Subject: Acton Town Council Comments on the Draft Decision Issued by the Office of Electrical Infrastructure Safety to Approve Southern California Edison Company's 2026-2028 Base Wildfire Mitigation Plan.

Reference: Docket #2026-2028-Base-WMPs.

**COMMENTS SUBMITTED BY THE ACTON TOWN COUNCIL
TO THE CALIFORNIA PUBLIC UTILITIES COMMISSION ON
SCE PSPS POST EVENT REPORTS.**

Figure 1. Bootlegger Circuit Map Showing Locations of Distribution Weather Stations.

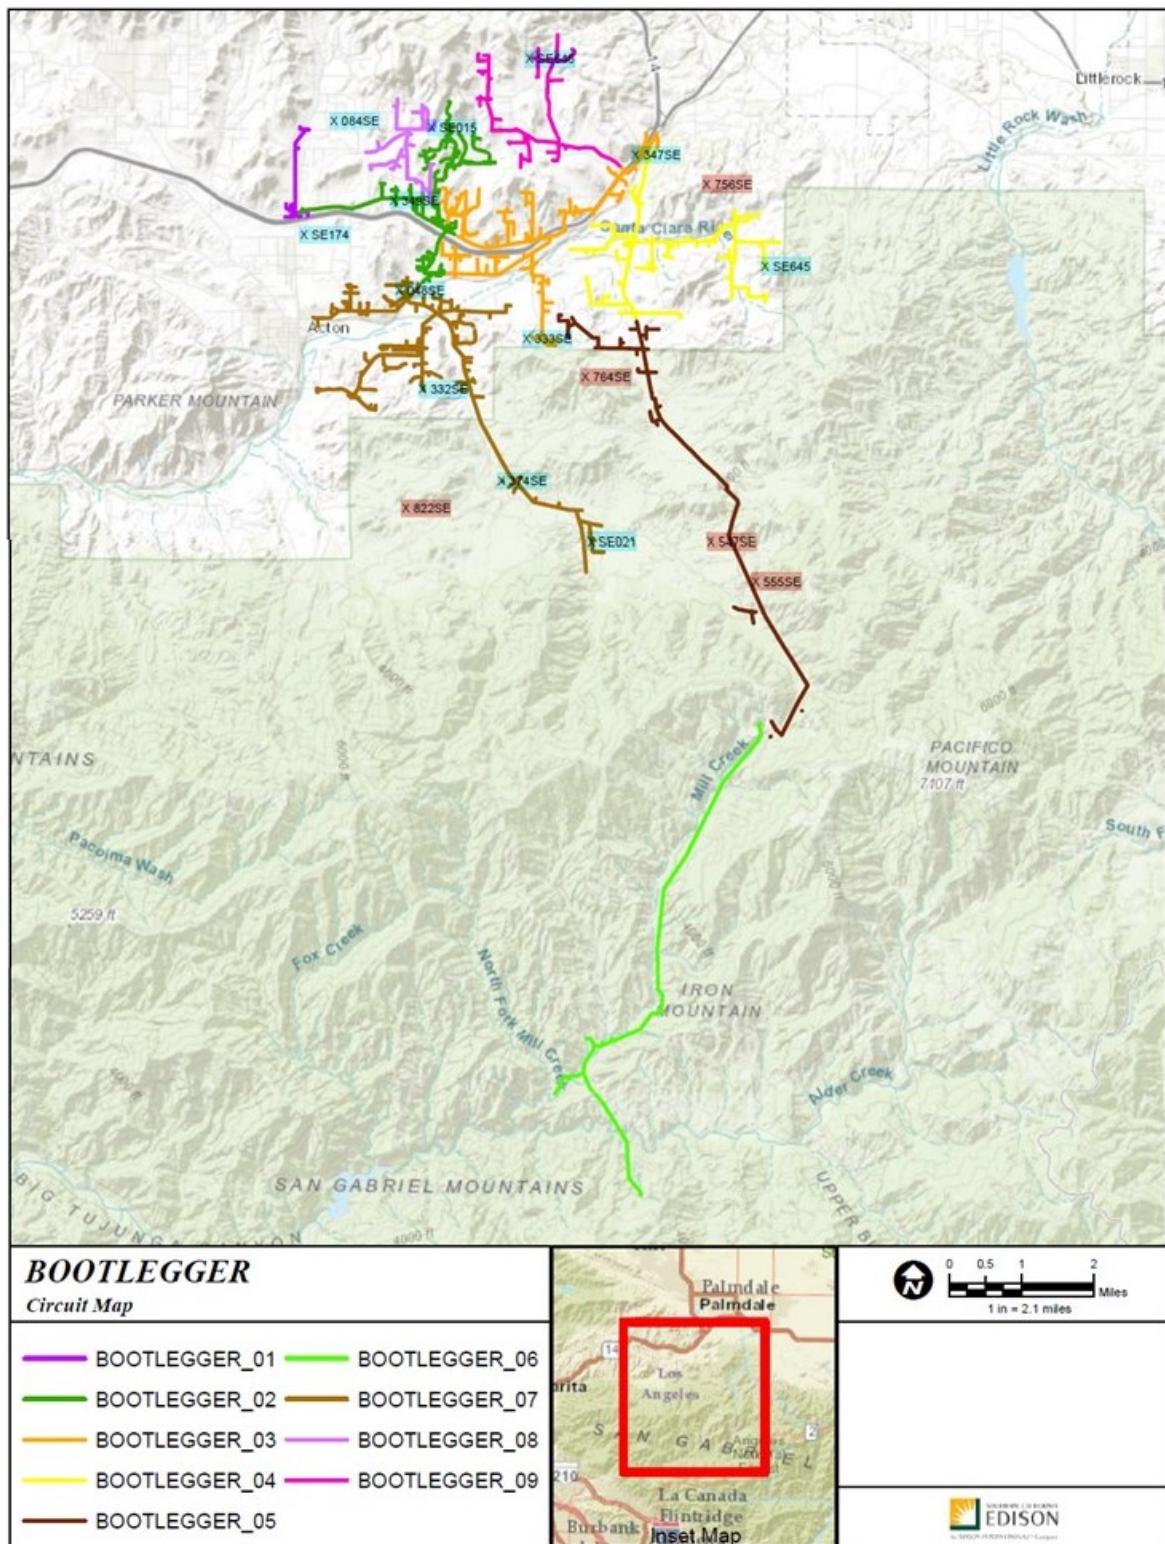
The Bootlegger Circuit During the January 17 PSPS event, SCE de-energized three segments of the Bootlegger Circuit in Acton (specifically, Segments 3, 4, and 5). The Council has mapped the locations of SCE weather stations on these Bootlegger segments; this map is provided in Figure 1. It must be noted that some of the weather stations indicated on this map are on transmission facilities located on ridgelines and are not on distribution facilities; these transmission facility weather stations are indicated with a different color. Based on this map, the Council downloaded weather data for each de-energized Bootlegger segment for the duration of the January 17 PSPS event and reconciled it with SCE's power shutoff notices issued for each Bootlegger segment. The results of this analysis are summarized in Table 1 which shows that the Bootlegger distribution circuit did not experience wind conditions that met or exceeded SCE de-energization thresholds either during the 12 hour period *before* power was shutoff or during the 12 hour period *after* power shutoff. Accordingly, *none* of the power shutoffs on the Bootlegger circuit during the January 17 PSPS event were warranted and *none* complied with SCE's PSPS protocols.

Tables 1 and 2 of SCE's "Workbook" report that the Bootlegger circuit was de-energized at 5:39 AM on January 20 because a wind gust of 52.3 mph was recorded. However, this wind gust measurement was actually recorded by an SCE **transmission** weather station located on a transmission tower high on a ridgeline in the Angeles Forest and many miles from where Acton residents were de-energized; therefore, it does not represent conditions on the Bootlegger distribution circuit and the data it records should **never** have been used to shutoff power to Acton residents⁶. Equally important, and as discussed in more detail below, wind gusts recorded by this transmission weather station throughout the January 17 PSPS event eventually reached 75.6 mph; yet, SCE never even considered shutting off power on this transmission line!

Figure 2. Shovel Circuit Map Showing Locations of Distribution Weather Stations.

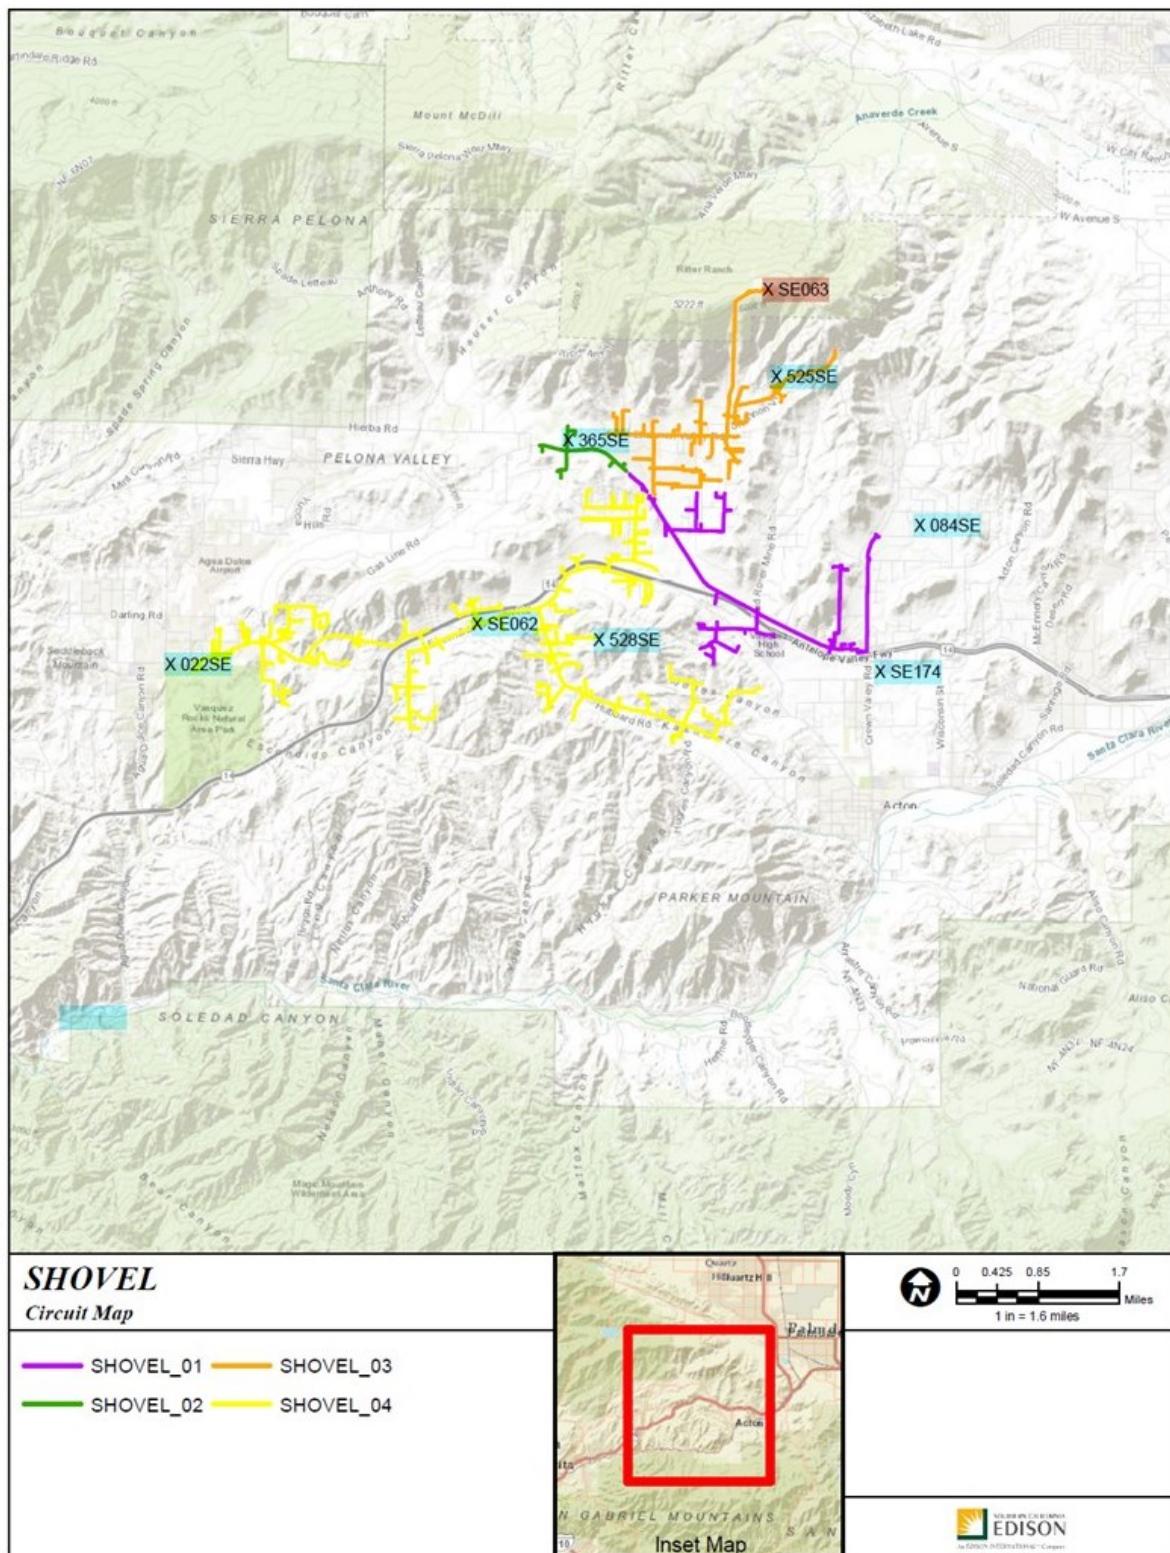
The Shovel Circuit: During the January 17 PSPS event, SCE de-energized all four segments on the Shovel circuit multiple times; a map of the Shovel circuit is provided in Figure 2 and it is marked to indicate the locations of weather stations on the various segments (indicated in blue highlights) as well as other weather stations (such as transmission and radio tower/communication facilities which are indicated in purple highlights). Based on this map, the Council downloaded weather data pertaining to the Shovel circuit for the duration of the January 17 PSPS event and reconciled it with SCE's power shutoff notices issued for each circuit segment. The results of this analysis are summarized in Table 2 which shows that the Shovel distribution circuit did not experience wind conditions that met or exceeded SCE de-energization thresholds either during the 12 hour period *before* power was shutoff or during the 12 hour period *after* power shutoff. Accordingly, *none* of the power shutoffs on the Shovel circuit were warranted during the January 17 PSPS event and *none* complied with SCE's PSPS protocols.

Figure 3. Pick Circuit Map Showing Locations of Distribution Weather Stations.

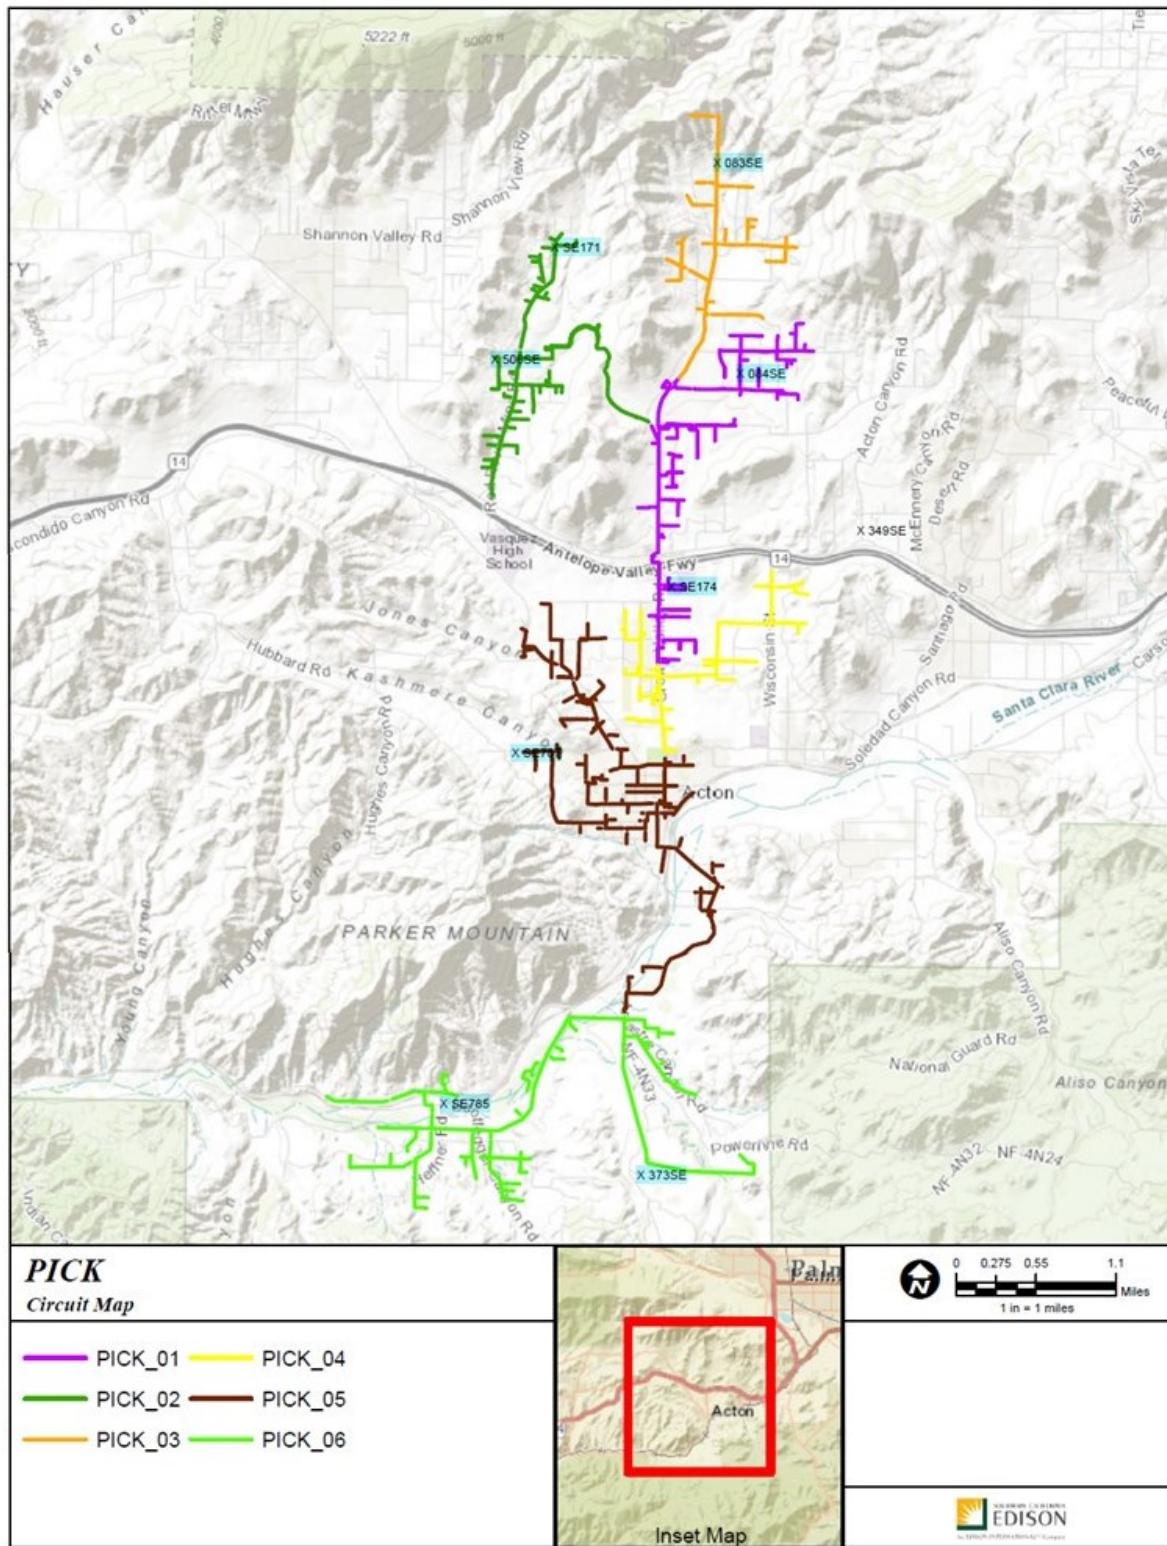
The Pick Circuit During the January 17 PSPS event, SCE de-energized all segments of the Pick Circuit (specifically, Segments 1, 2, 3, 4, 5, and 6). The Council has mapped the locations of SCE weather stations on these Pick segments; this map is provided in Figure 3. Based on this map, the Council downloaded weather data for each de-energized Pick circuit segment for the duration of the January 17 PSPS event and reconciled it with SCE’s power shutoff notices issued for each segment. The results of this analysis are summarized in Table 3 which shows that no segments of the Pick circuit experienced wind conditions that exceeded SCE’s de-energization thresholds of 40 mph sustained winds and 58 mph wind gusts⁷. It is noted that the wind gusts recorded for Pick Segment 2 are higher than the wind gusts recorded elsewhere on the Pick circuit; this is because Segment 2 is an offshoot that extends into a broad shallow valley known as Red Rover Mine Valley. Data recorded by SCE Weather Stations over the last 6+ years clearly demonstrate that wind conditions in the Red Rover Mine Valley are unique and do not reflect wind conditions elsewhere in Acton. Just before SCE de-energized the Pick circuit at 9:20 on January 20, a wind gust of 56.9 mph was recorded on a weather station on Segment 2; because this wind gust was close to the 58 mph de-energization threshold that SCE has established for the Pick circuit, it would perhaps provide SCE with sufficient basis to de-energize Pick Segment 2. However, *it did not under any circumstance provide any basis* for SCE to de-energize the entire Pick circuit; yet, by 11:15 that day, power was shutoff to every customer on the Pick circuit. As Table 3 demonstrates, *none* of the power shutoffs on Segments 1, 3, 4, 5, and 6 were warranted and *none* complied with SCE’s PSPS protocols.

Additionally, a comparison of Figures 1 and 3 reveal that the weather stations which monitor conditions on Bootlegger Segments 1 and 2 are the same weather stations that monitor conditions on Pick Segments 1 and 4. Yet, during the January 17 PSPS event, SCE never cut power on Bootlegger Segments 1 and 2, *but it did cut power on Pick Segments 1 and 4*. This was intrinsically unreasonable because Bootlegger Segments 1 and 2 experienced the same wind conditions as Pick Segments 1 and 4; because SCE did not shutoff power to Bootlegger Segments 1 and 2, it should not have shutoff power to

Figure 4. Sand Canyon Circuit Map Showing Locations of Weather Stations.

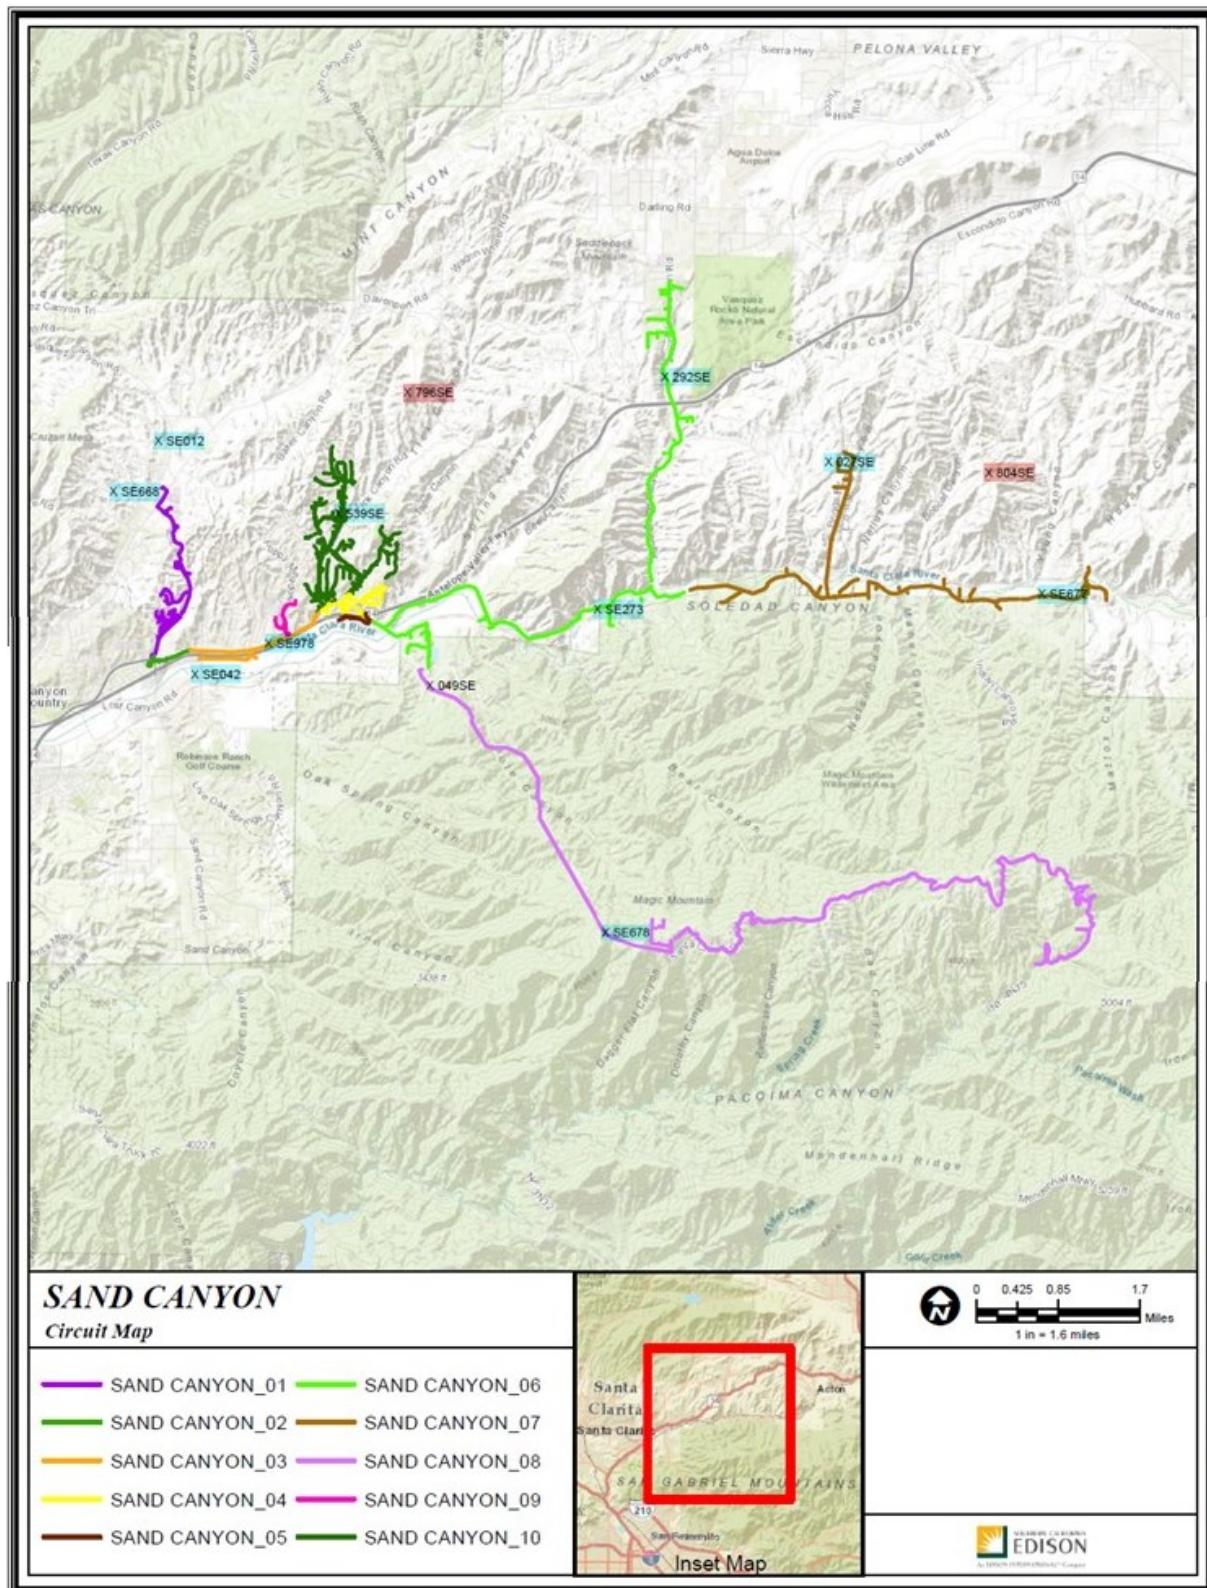
The Sand Canyon Circuit. Because SCE’s Post Event Reports provide no data on when circuit segments were de-energized and because SCE never sends the Council any PSPS notices regarding the Sand Canyon circuit⁸, we have no specific information regarding when the various segments on the Sand Canyon circuit were de-energized (although we understand that Acton residents served by the east end of the Sand Canyon circuit were de-energized during the January 17 PSPS event). However, we have been able to reconstruct some of SCE’s de-energization activities on the Sand Canyon circuit and are able to provide the following analysis of these activities and whether they were reasonable and appropriate.

According to Tables 2 and 5 of SCE’s “Workbook”, the Sand Canyon Circuit was de-energized at 6:56 AM on January 20 because sustained winds of 44.6 mph and a wind gust of 68 mph were recorded. The Council has reviewed the wind data reported by all the weather stations on the Sand Canyon distribution Circuit (shown in Figure 4) and found only one weather station that recorded windspeeds exceeding SCE’s de-energization thresholds. This weather station (“SE678”) is located on a power line off shoot that extends to a remote radio and cellular communication facility at a 4500 foot

elevation (approximately) on a ridgeline surrounded by the Magic Mountain wilderness area. It appears that the only customer served by this power line off shoot is the communication facility itself and, as indicated in Figure 4, SCE has segmented it from the rest of the Sand Canyon circuit; SCE refers to it as “Segment 8”. Weather Station “SE678” recorded a sustained wind speed of 44.55 mph and a wind gust of 67.95 mph at 6:50 AM on January 20, so the Council assumes that this is the wind measurement that is noted in Table 2 of SCE’s Workbook. At 9:50 that same morning, this particular weather station recorded a sustained wind speed of 44.55 mph and a wind gust of 67.95 mph. These data indicate that it was certainly appropriate that SCE de-energize Segment 8 of the Sand Canyon circuit; however, there does not appear to be any justification for de-energizing other segments on the Sand Canyon Circuit. In fact, and insofar as the Council is able to discern, the only weather station that recorded wind data approaching (but not reaching) SCE’s de-energization thresholds is “027SE” which, as indicated in Figure 4, is located on an offshoot power line that extends north into Long Canyon from the east side of the Sand Canyon circuit. This offshoot power line up Long Canyon serves the Briggs Road neighborhood of Agua Dulce and unfortunately, SCE has never bothered to sectionalize it from the rest of the Sand Canyon circuit. As a result, SCE routinely and improperly de-energizes the entire east half of the Sand Canyon circuit (including Acton residents in the Santa Clara River Valley) based on windspeeds measured by Weather Station No. SE678 located several miles away and far up a canyon. In other words, there is no apparent justification for SCE’s de-energization of Acton residents on the Sand Canyon circuit during the January 17 PSPS event and had SCE properly implemented sectionalization, these shutoffs in Acton would have been avoided.
